ADDENDUM

NO. 1

PROJECT NAME: New Operations Building

PROJECT NUMBER: 1971-05-01

PACKAGE	VOLUME
Job No. 1971-05-01	Sheet No. E1.04
Drawn By: HB/BRH	
Date: 09/18/2025

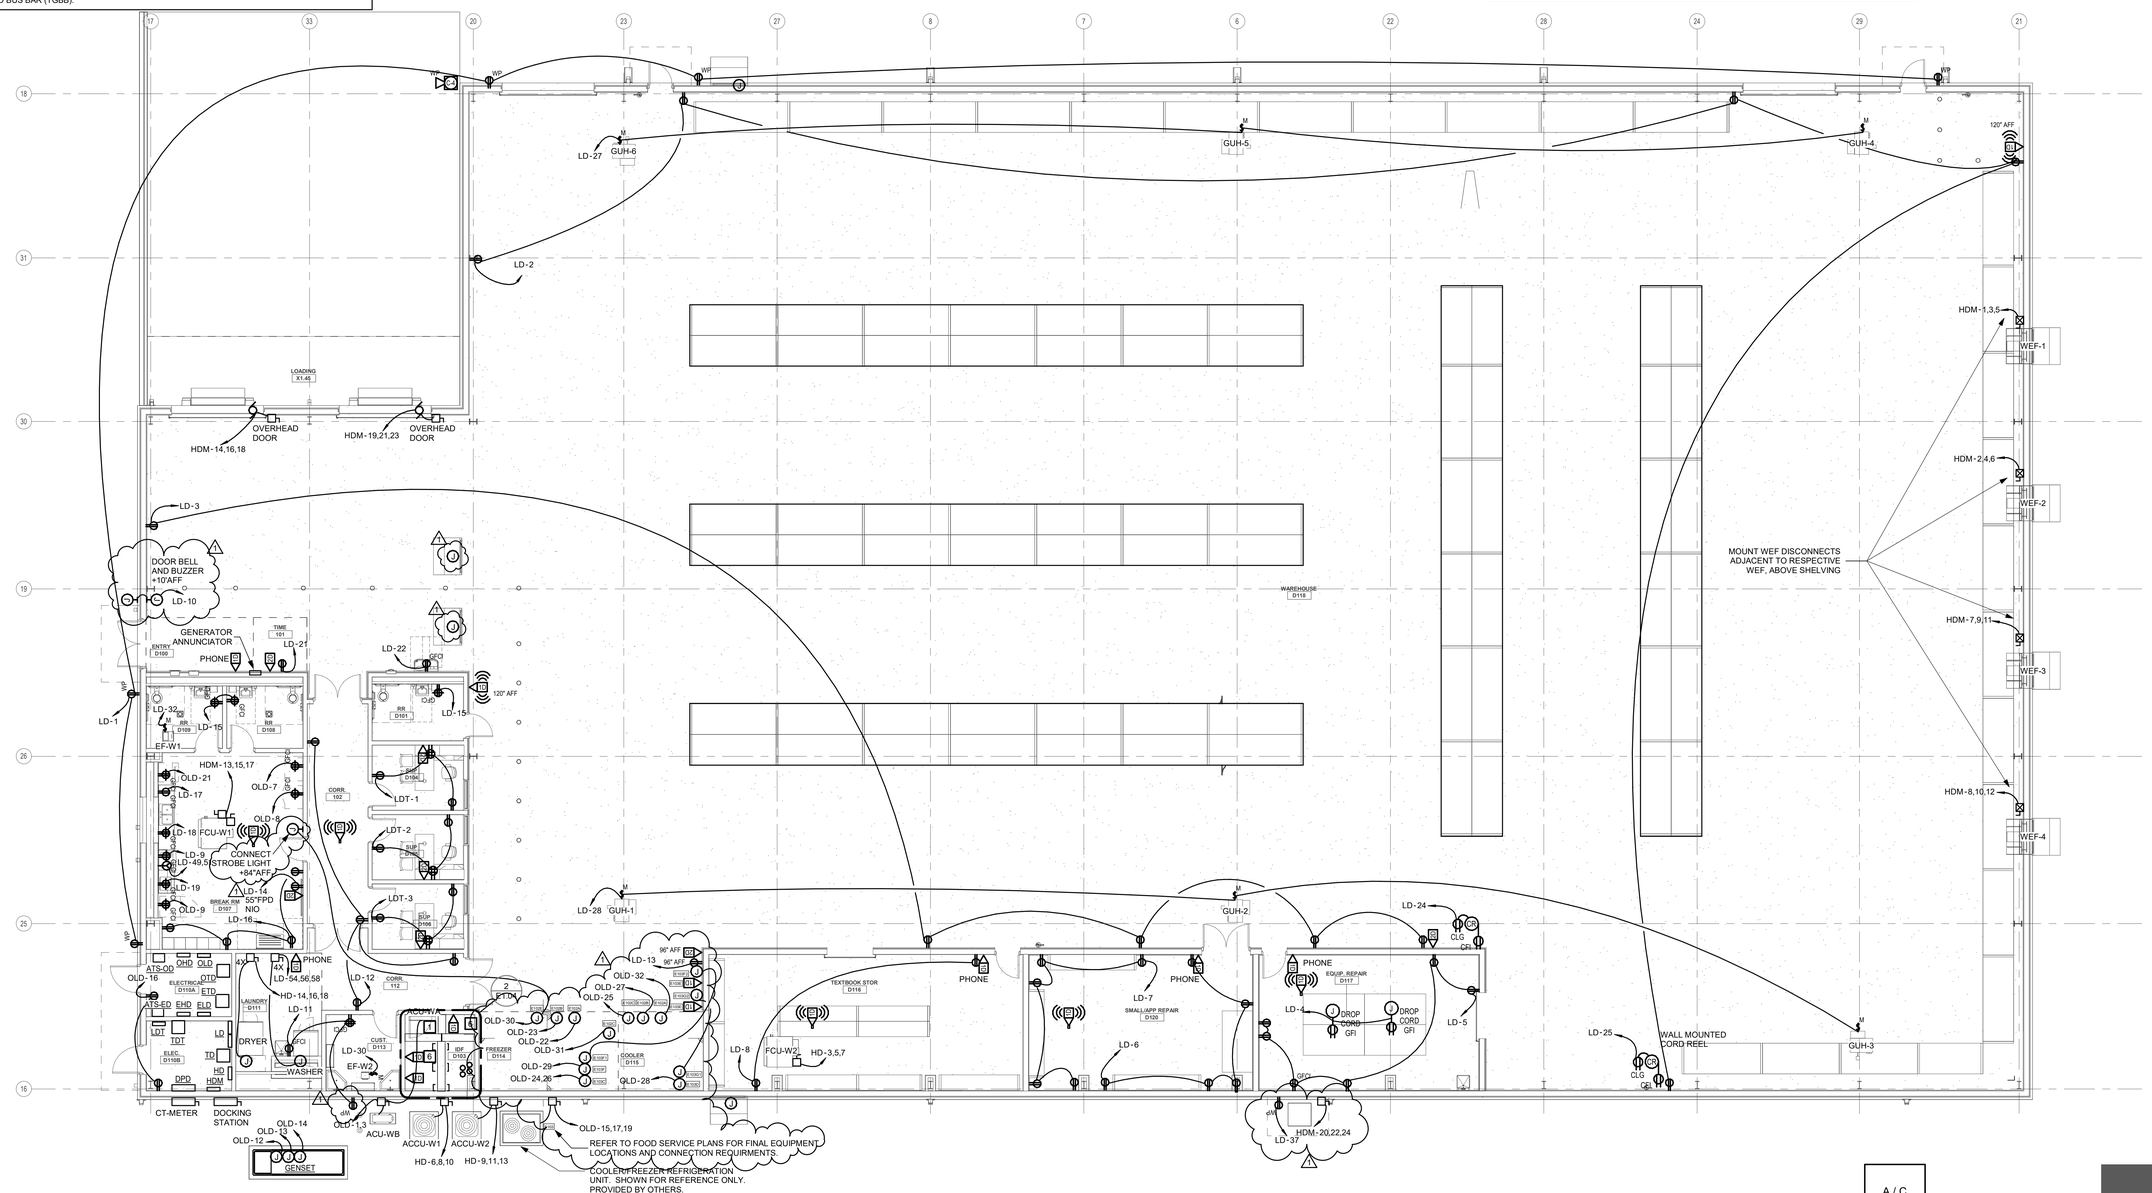
AD No 1, Elec. Item 10: To the Drawings, Sheet E1.04, "ELECTRICAL FLOOR PLANS – LEVEL 1 – AREA D - WAREHOUSE"

PACKAGE	VOLUME
Job No. 1971-05-01	Sheet No. E1.05
Drawn By: HB/BRH	
Date: 09/18/2025

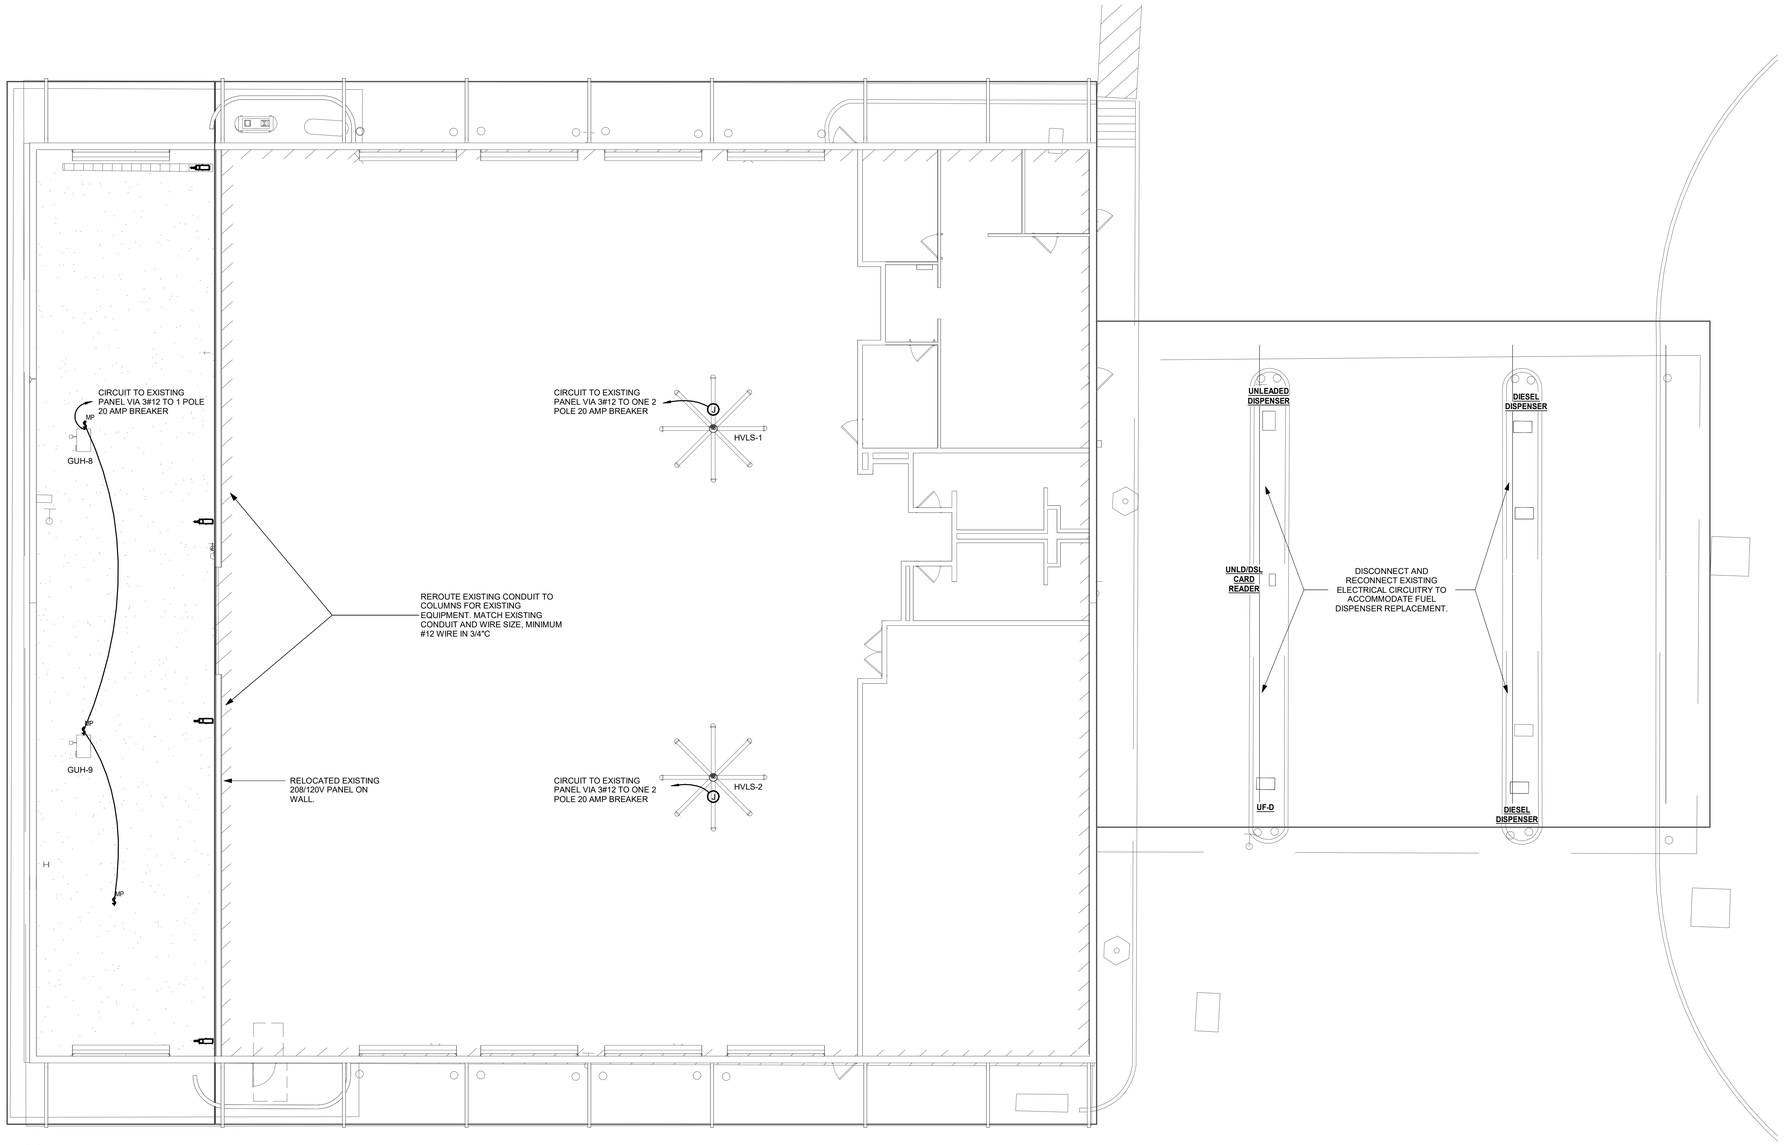
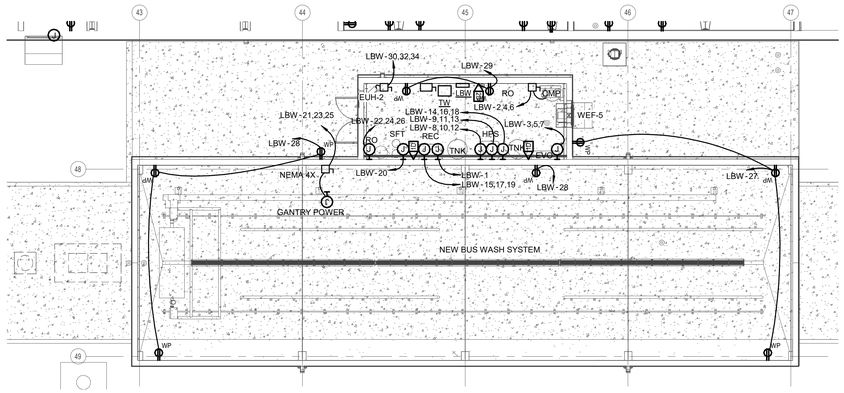
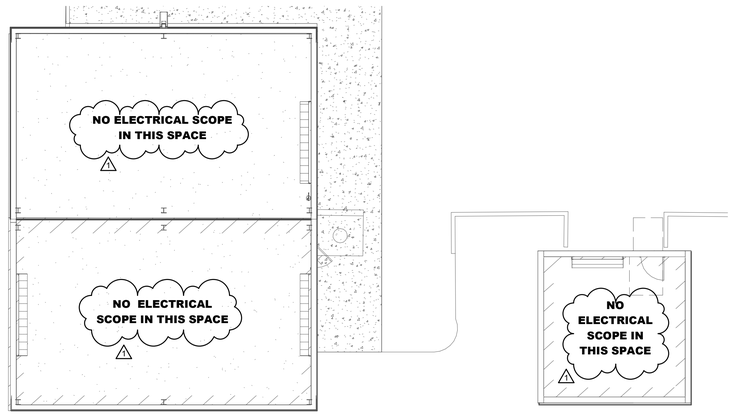
AD No 1, Elec. Item 11: To the Drawings, Sheet E1.05, "ELECTRICAL FLOOR PLANS - BUS WASH, MECHANIC BAY & STORAGE"

PACKAGE	VOLUME
Job No. 1971.05.0	Sheet No.
Drawn By: HB/BRH	ISSUED FOR B
Date 09/18/2025	E1.06

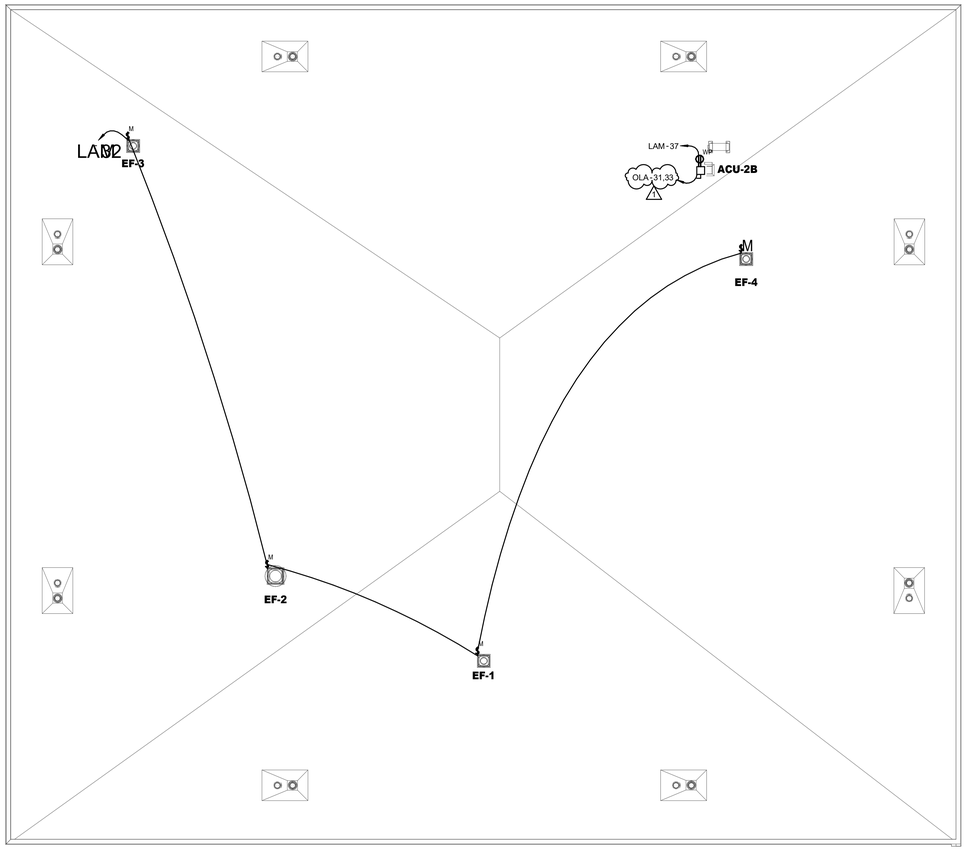
AD No 1, Elec. Item 12: To the Drawings, Sheet E1.06, "ELECTRICAL ROOF PLAN"

Job No.	Sheet No.
1071-05-01	E2.02
Drawn By: HB/BRH	
Date: 09/18/2025

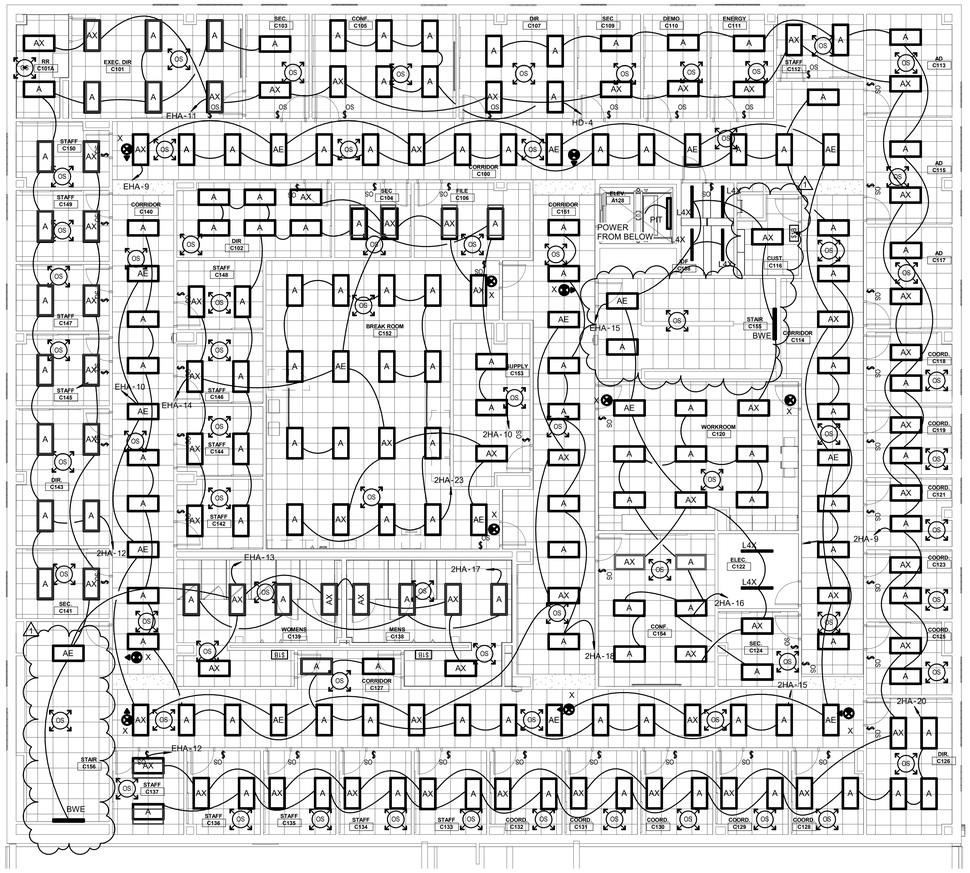
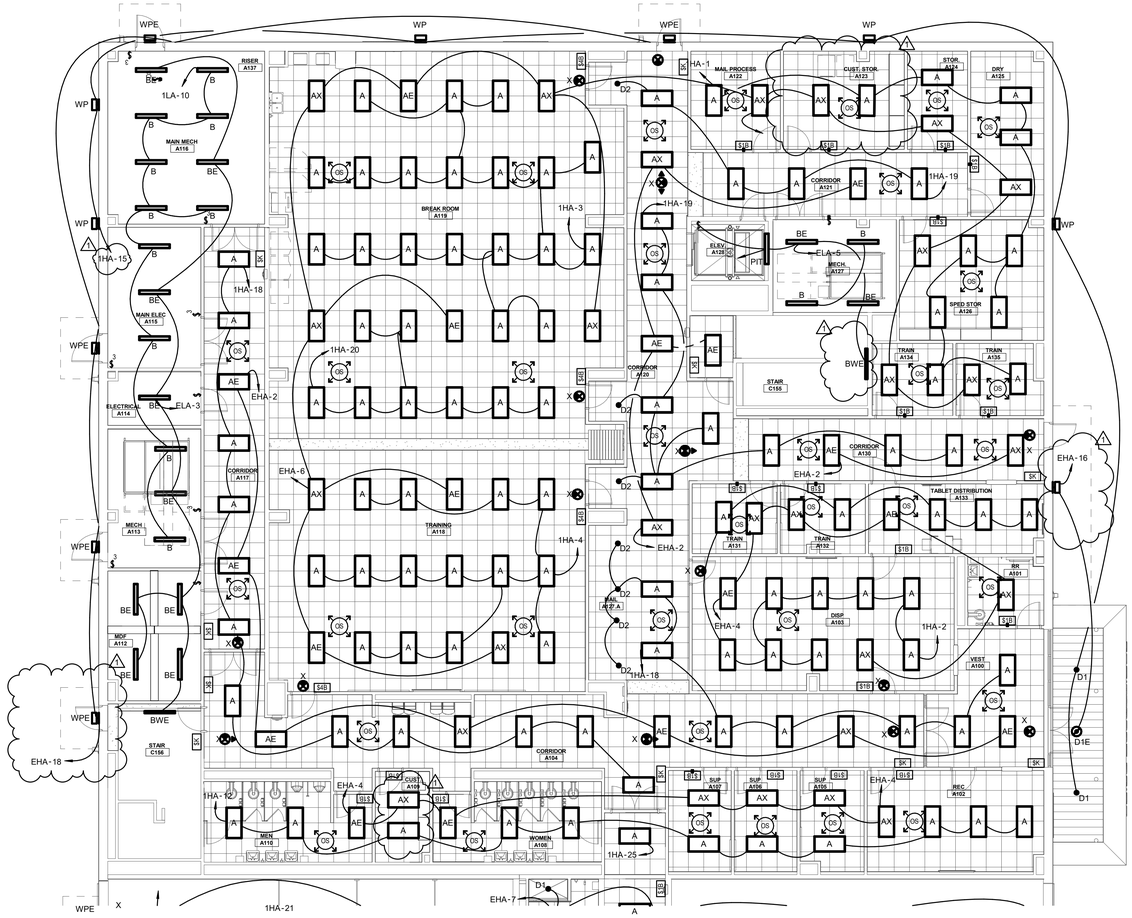
AD No 1, Elec. Item 13: To the Drawings, Sheet E2.02, "LIGHTING REFLECTED CEILING PLAN – LEVEL 1 / 2 – AREA A / C – OPERATIONS BUILDING,"

Job No.	Sheet No.
1971-05-01	E2.03
Drawn By: HB/BRH	
Date: 09/18/2025

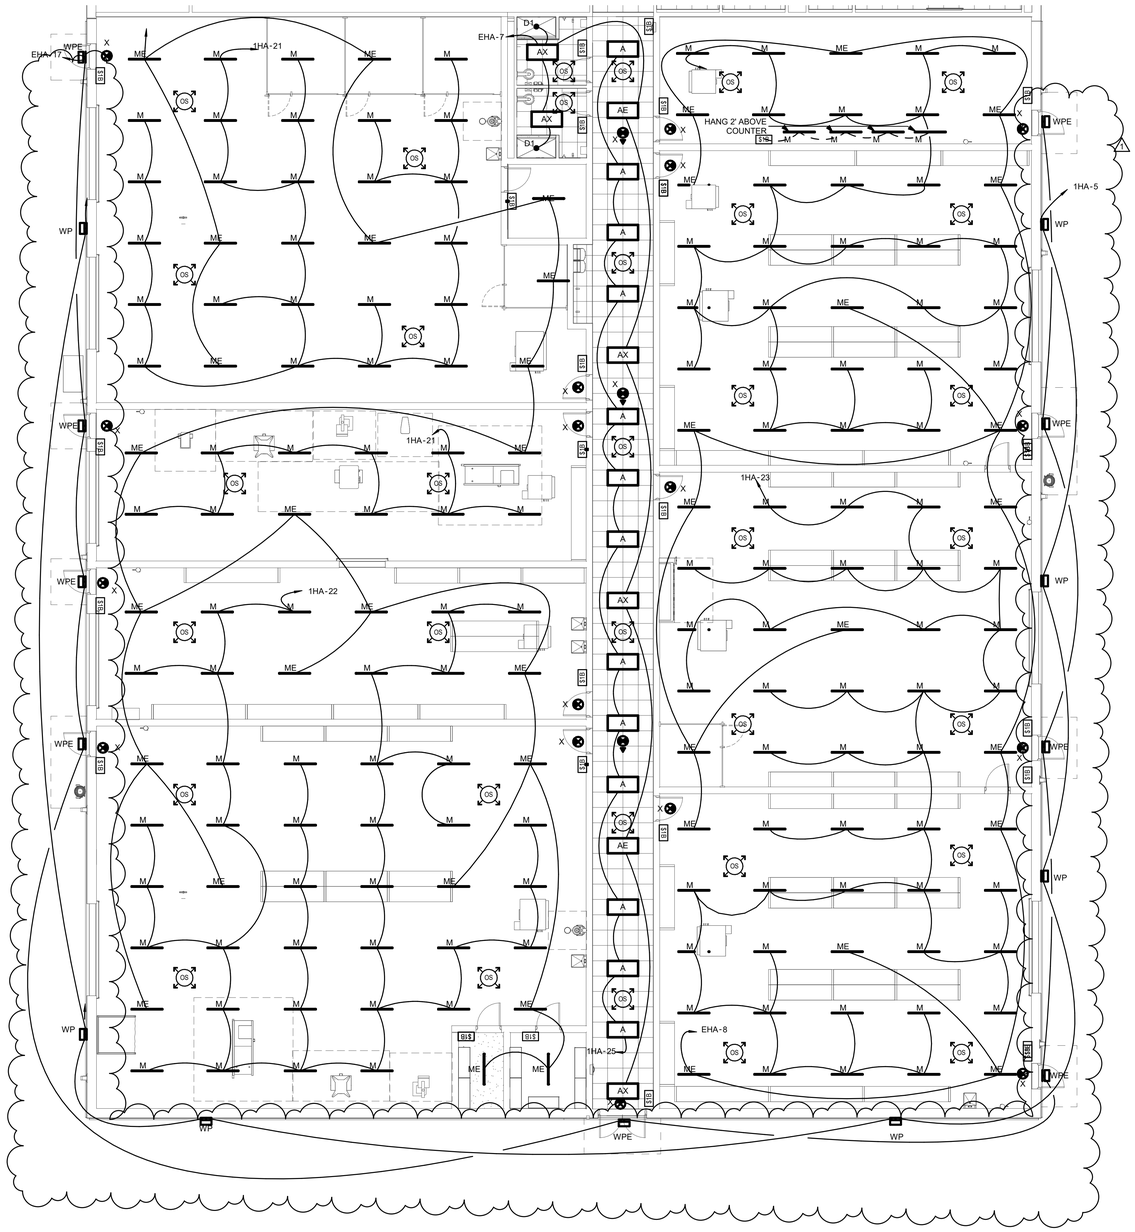
AD No 1, Elec. Item 14: To the Drawings, Sheet E2.03, "LIGHTING REFLECTED CEILING PLAN – LEVEL 1 – AREA B – OPERATIONS BUILDING,"
